SERVICE BULLETIN

Model: 4-180 kW

Subject: **Fuel Pump Inspection**

Figure 1 Fuel Pump

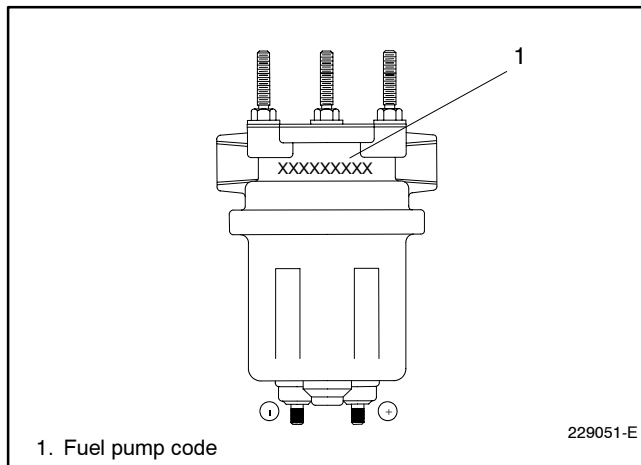
1. Check all service parts stock for fuel pumps with a manufacturer's build code of 11560A13A or 11560A25 stamped on the housing. See Figure 1 for the fuel pump's code location. Replace all fuel pumps that have this code.
2. Locate the affected generator sets. Inform the owner of this issue and make arrangements to replace the suspect fuel pump. Replace all fuel pumps with a code of 11560A13A or 11560A25 stamped on the housing.
